Re: Application FW32A/0111

Subject Site: Lands at Huntstown and Coldwinters Townland, Co. Dublin

We refer to application FW32A/0111 and attach herewith our response to matters raised in the Further Information request dated 14th June 2023.

Figures 4-8 Extract from site sections

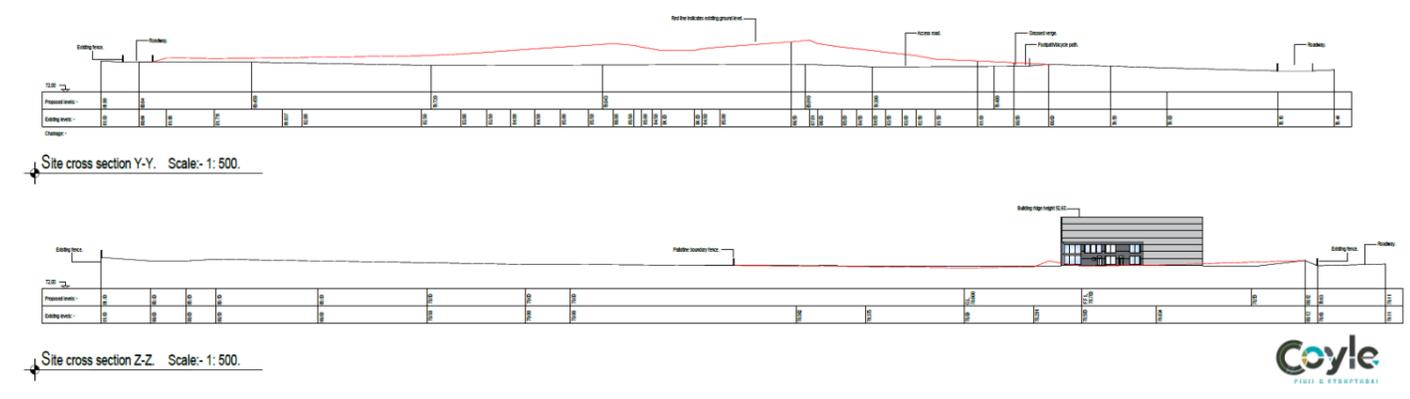
- (a) A section drawing which extends the section drawing A-A (as illustrated on site layout plan, P001) across the site. This shall show the eastern site boundary, existing ground level and proposed ground level and the proximity of works to the eastern site boundary.
- (b) A site section drawing which starts at the end point of the road carriageway on the southeast boundary. This shall show the site boundary, existing ground level and proposed ground level and the proximity of works to the south eastern site boundary.
- (c) Following preparation of this, the applicant shall review the separation distances from proposed works and the site boundary as stated in the Environmental Impact Assessment Report and Planning and Design Statement and make any revisions to the texts and assessment as necessary.

Response: We refer to accompanying drawings by Coyle Civil & Structural; specifically drawings P007 (Rev A). Section A-A has been updated to include for proposed levels from the existing public road in charge of Fingal CoCo and across the south-eastern site boundary and extends approximately 82 metres into the site.

Site sections have also been included in drawing P007 that run from north-east to south-west (section X-X), east to west (section W-W) and north to south (sections Y-Y and Z-Z). These sections demonstrate the existing and proposed levels to the site.

Figure 9 Iteration 1

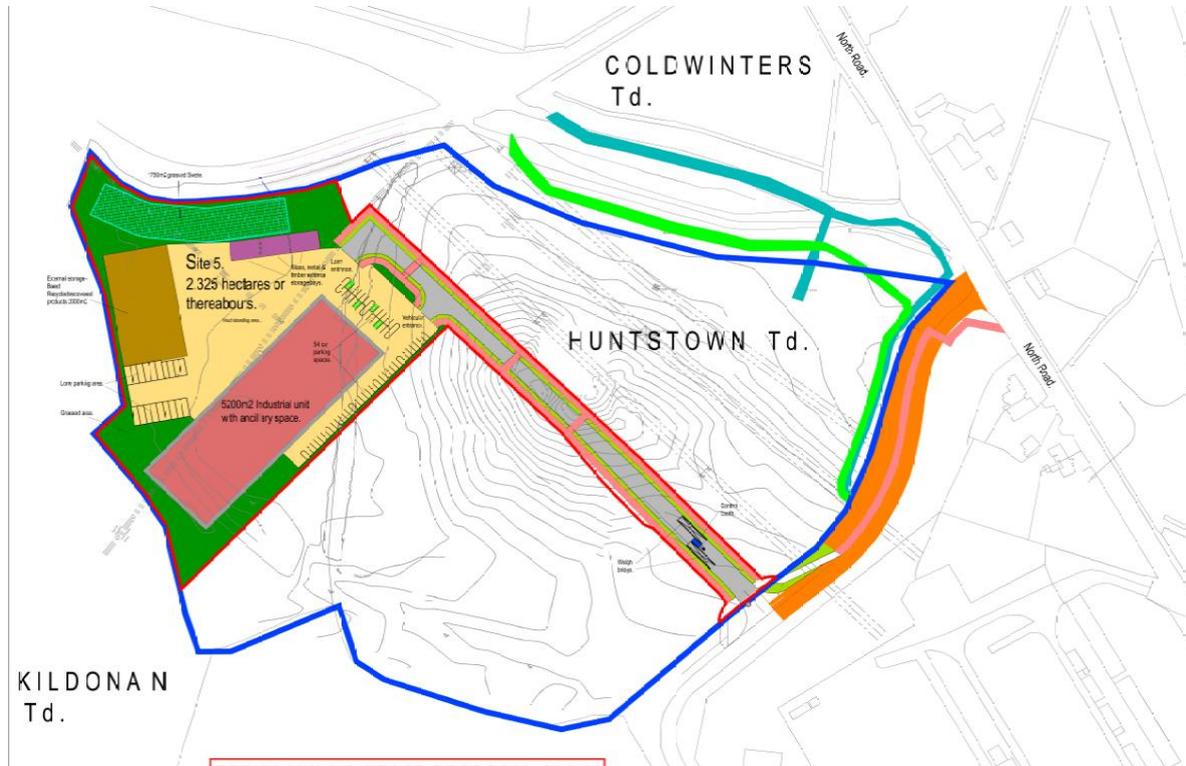
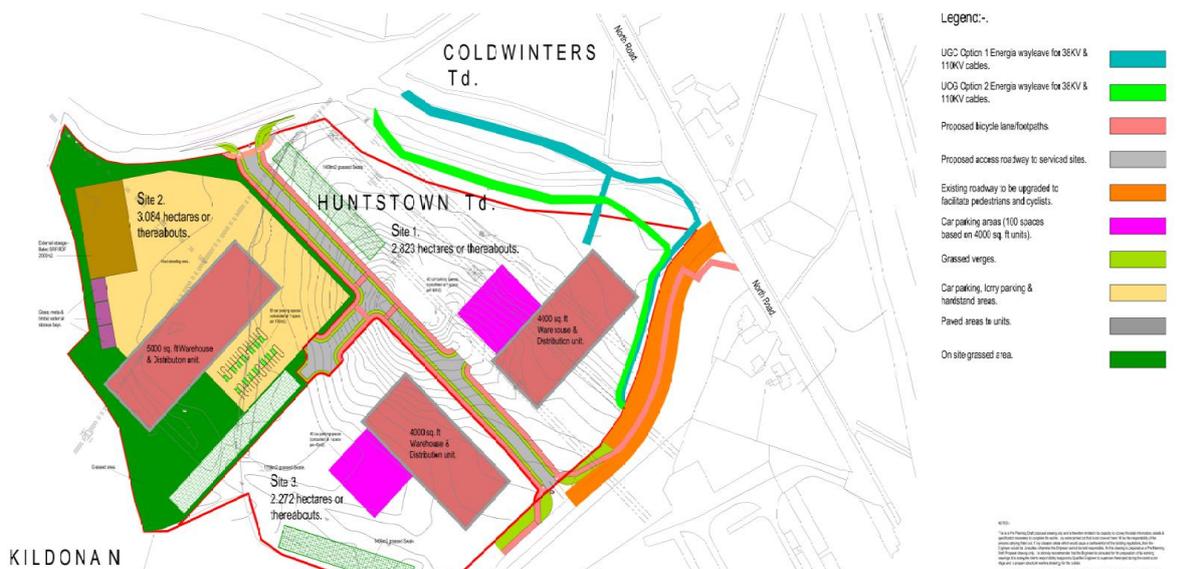
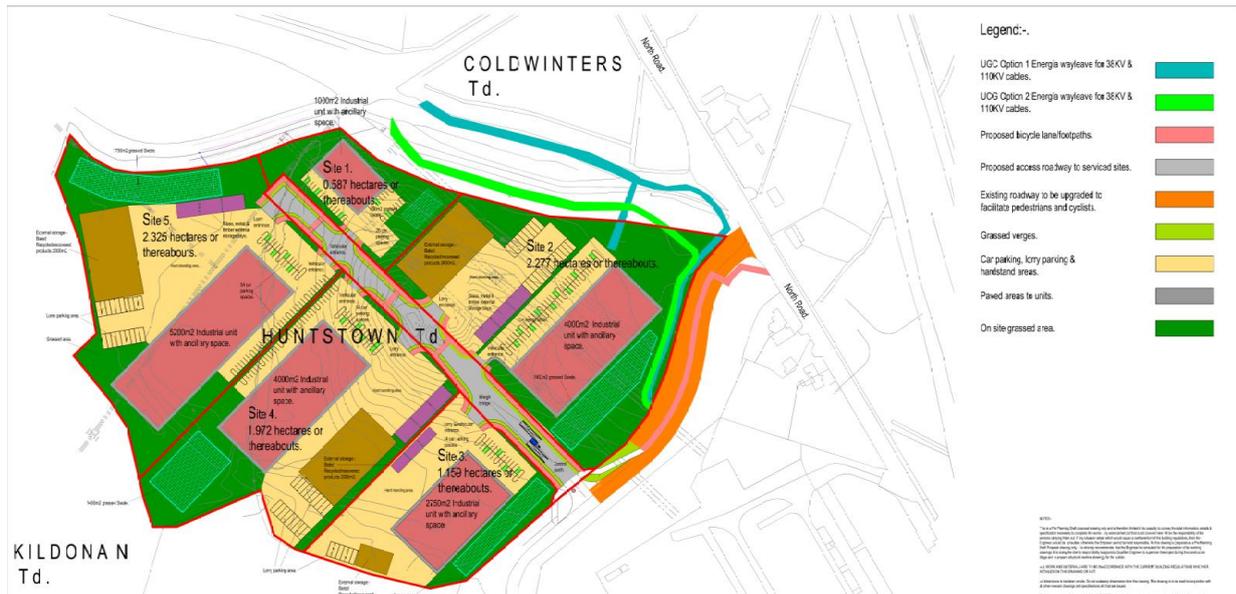
d. The Alternatives section of the EIAR should be revised to appropriately consider potential alternative site layouts (e.g. Iteration 2), which has lesser impact on the western and southern site (townland) boundaries. The assessment of alternatives should be presented as a clear environmental assessment, with conclusive reasoning for choosing the selected alternative.

Response: As referred to in section 4.2 of the original EIAR the evaluation of alternative site layouts was determined by a combination of the site's physical constraints and relevant policy and guidance documents. The constraints were evaluated by the Design Team and the appropriate avoidance, prevention and mitigation measures were incorporated into the design.

Figure 15 Extract from drawing no. 7670 L2101 annotated to identify specific hedgerow proposals

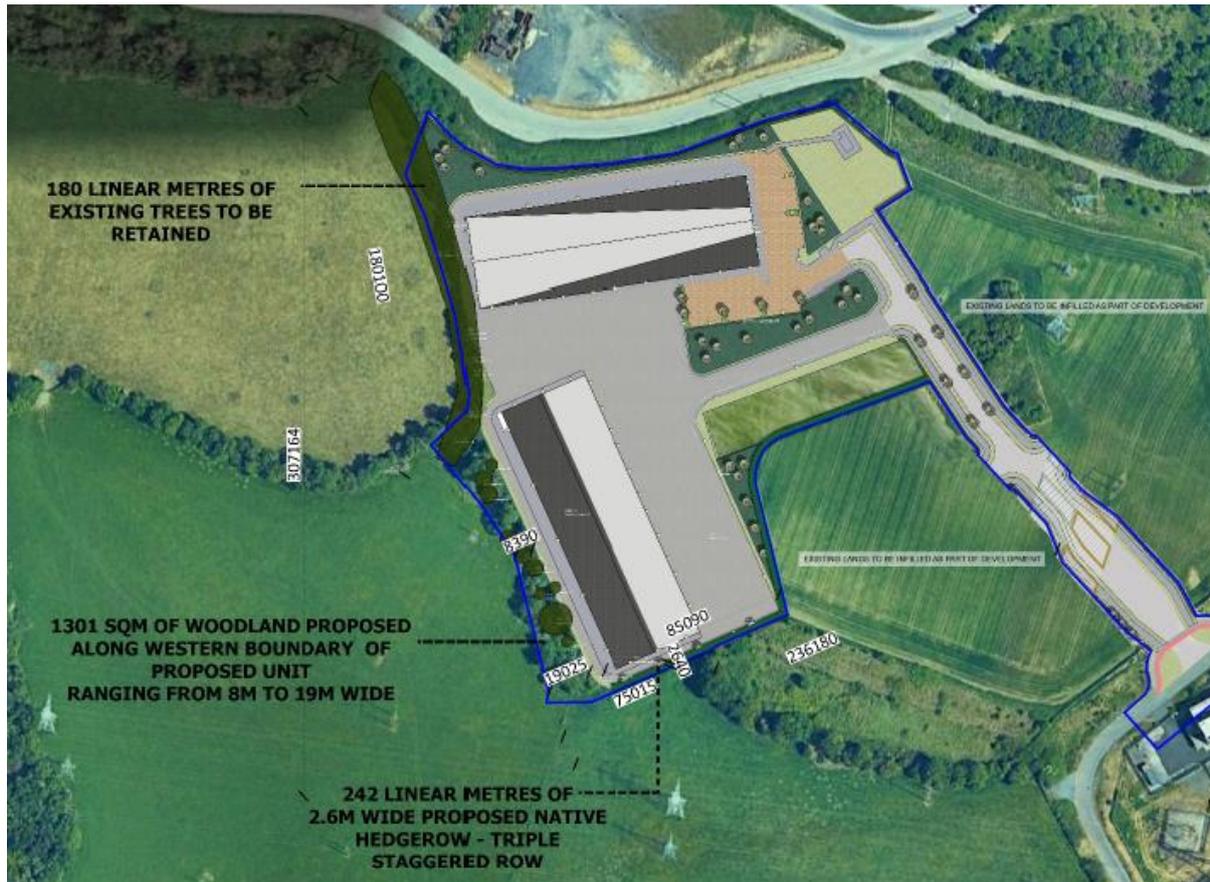
f. The documents submitted with the application, including the EIAR, acknowledges the significance of the trees and hedgerows on the western and southern boundary of the site. The documentation states that this boundary will be retained, protected and augmented. This boundary is also a townland boundary/feature. However, it is considered that the proposed development does not make adequate provision for the protection, retention and augmentation of this significant cultural, ecological and landscape feature either in terms of appropriate setback - stated as being 7 to 10m in the planning and design statement (Section 4.2, Genesis Planning) - or in terms of its full retention. In many places, aspects of the proposed development are significantly closer to the hedgerow and in-part it is proposed to remove a section of the feature entirely. The applicant is requested to revise the layout of the proposed development so as to maintain the stated setback of 7m minimum from any aspect of the proposed development, including fencing, to the edge of the vegetation in the townland boundary. The revised layout shall have regard to the findings, including root protection areas, and any recommendations for retention of trees / hedgerows of amenity value, in the updated arboricultural survey.

Response: This is addressed in the updated site layout plan and the closest point of buildings is 9.47 metres from the main western site boundary, The arborist's report and survey has also informed separation distances.

The layouts have been amended to allow for the retention of the western hedgerow (total length c.307m) and its augmentation where weak with additional native hedgerow species to gap up these sections. Further, the hedgerows will be given appropriate management to remove ivy, remove dead material and cut back the hedge faces to return them to a more compact form in line with their original intent.

On the inside (or within the application site), native woodland belts will be planted that will further augment the boundary vegetation in this area as it matures. The minimum depth of any boundary vegetation will be 7m and, in sections, the existing hedge and proposed woodland belt will be of up to 16m wide. The area of proposed woodland plant equates to 1,300m² in total.
